# Request for Interpretation Response

Project Name: Surgical Tech Sim Suite
Project No.: 26053
Owner: NWACC

RFI NO: **01**
Date of Request: 11/5/2026
Date of Response: 11/6/2026

1 SECOND FLOOR SPECIAL SYSTEMS PLAN
1/8" = 1'-0"

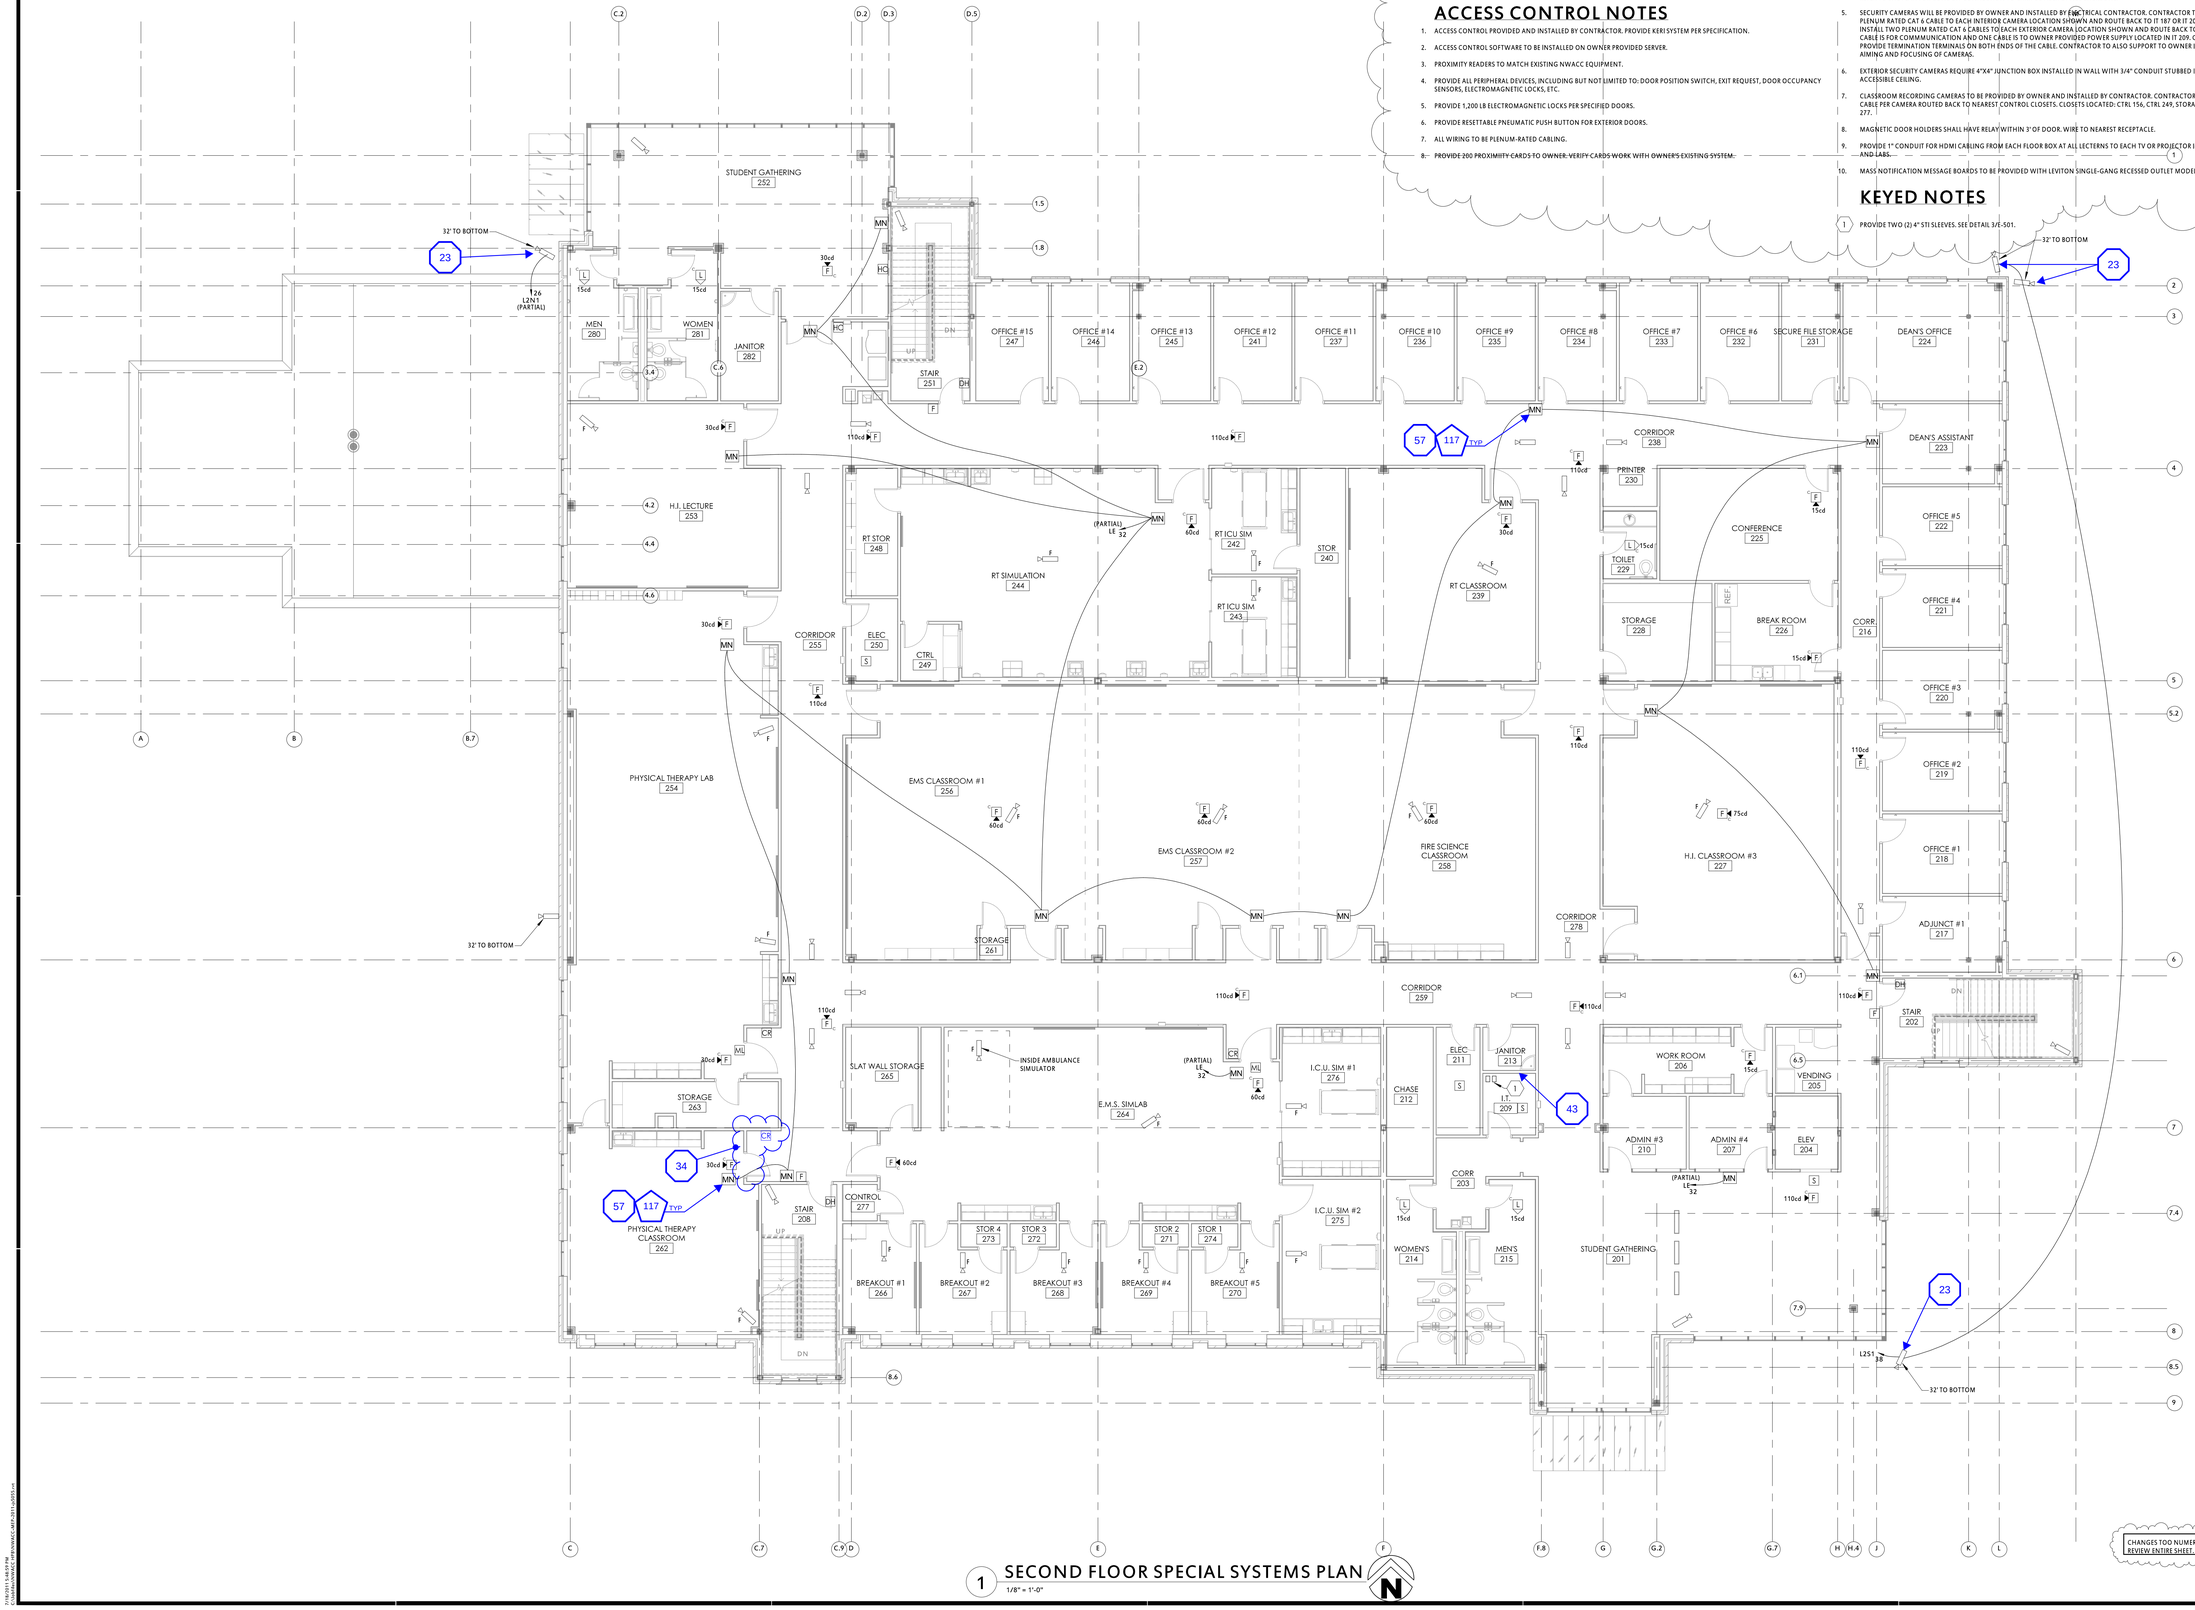
Item 18) ***Revision*** RE: Attached E-110 through E-113 for revisions to special systems plans (1st through 3rd floor).

CHANGES TOO NUMEROUS TO CLOUD, REVIEW ENTIRE SHEET. 1

1 THIRD FLOOR SPECIAL SYSTEMS PLAN
1/8" = 1'-0"

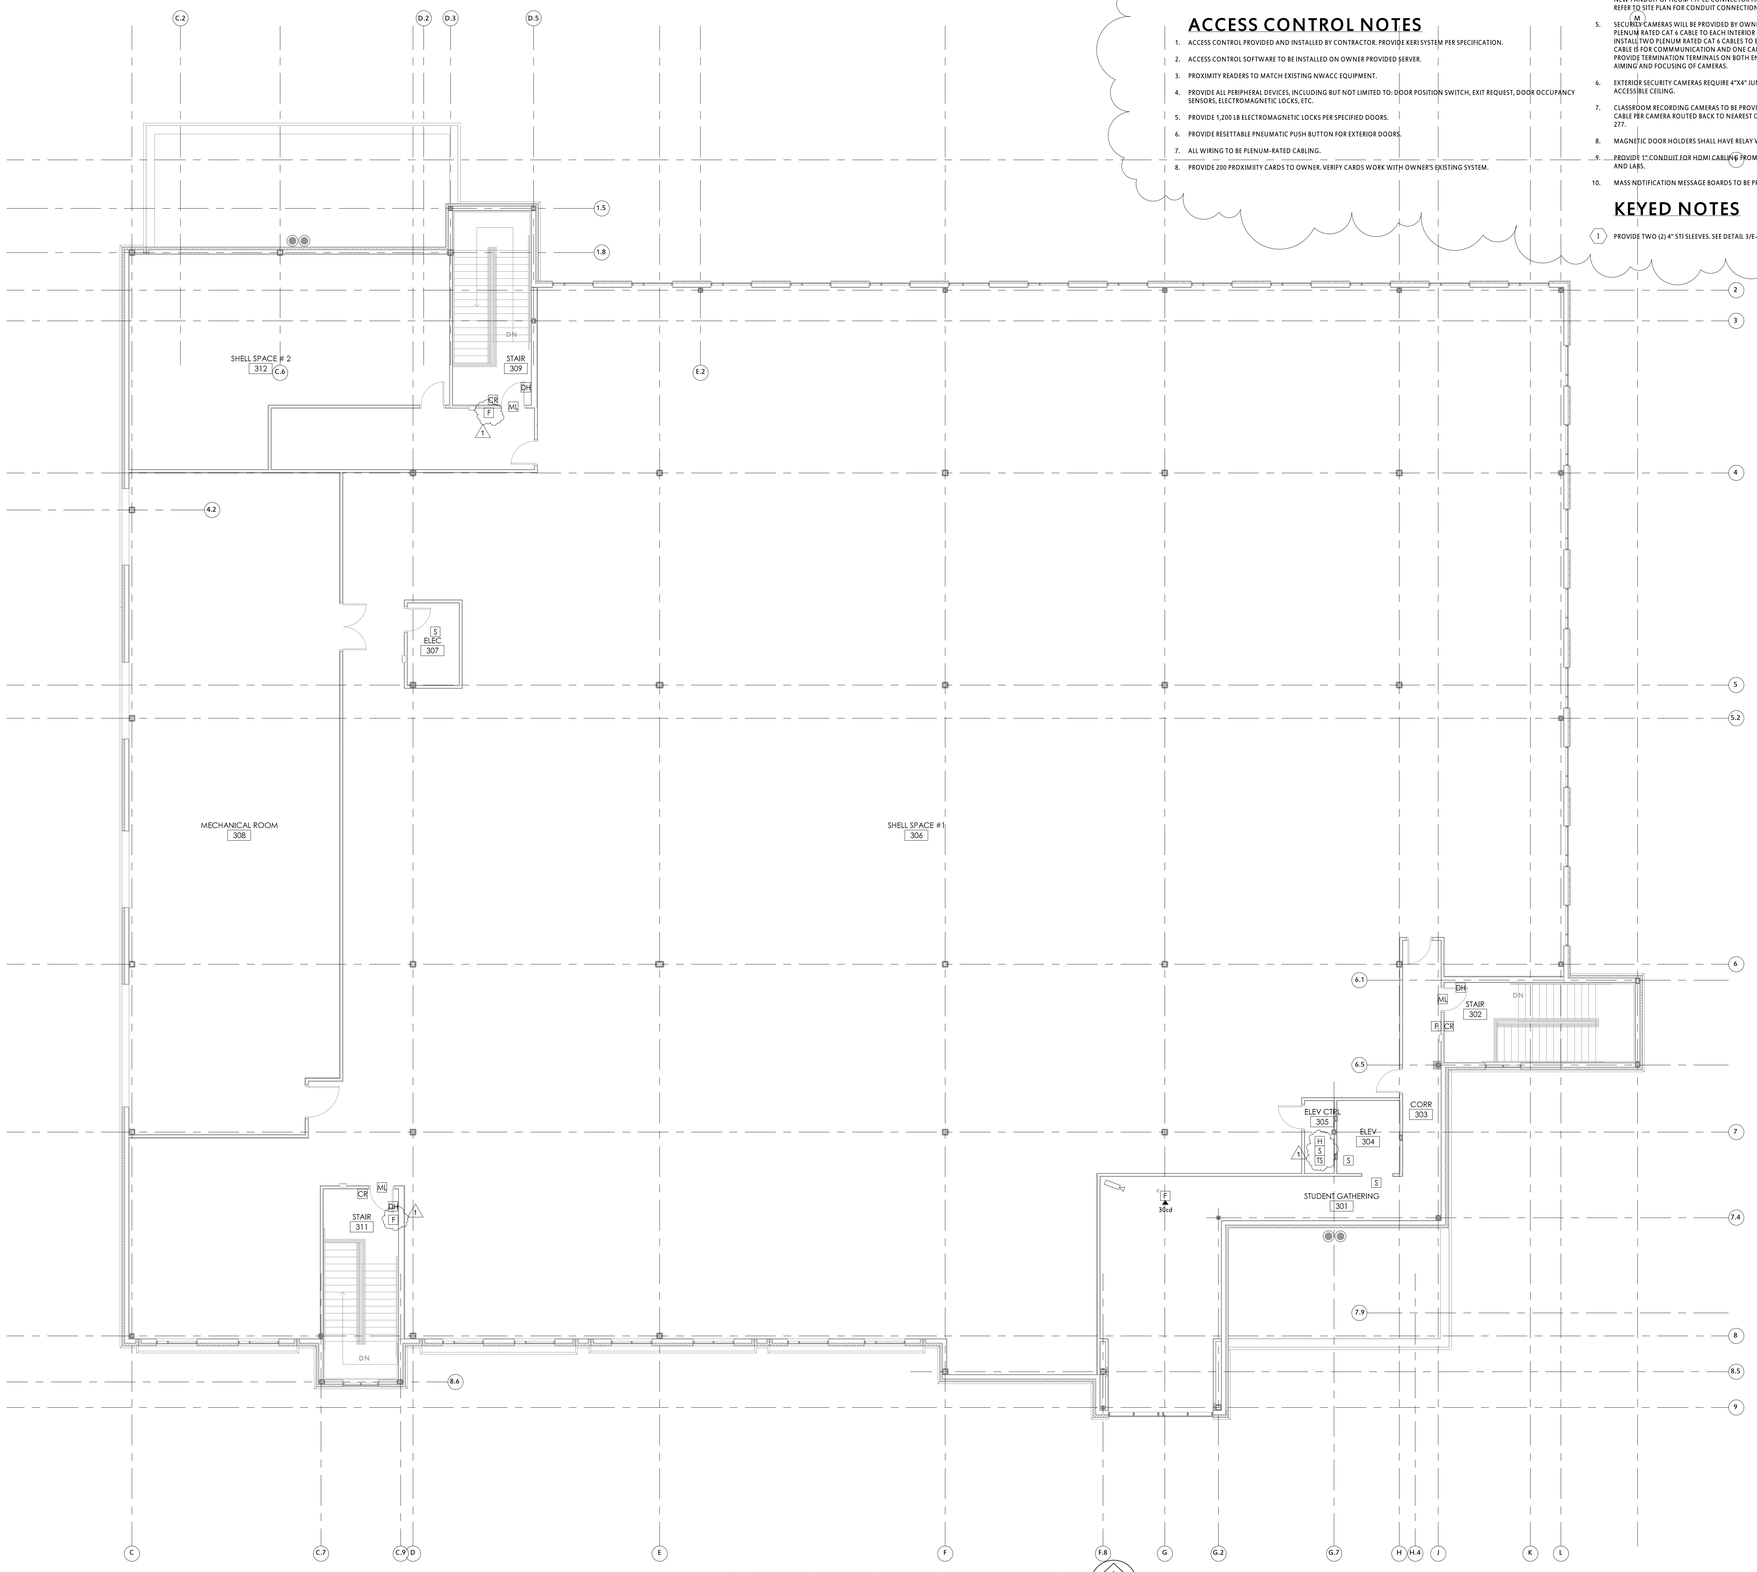
Item 18) ***Revision*** RE: Attached E-110 through E-113 for revisions to special systems plans (1st through 3rd floor).

## 8 CODE BLUE BASE DETAIL
1/8" = 1'-0"

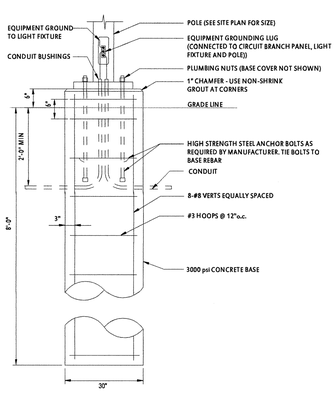
2 Item 15) ***Addition*** RE: Attached EAD-05, for base detail for site emergency phone pylon.
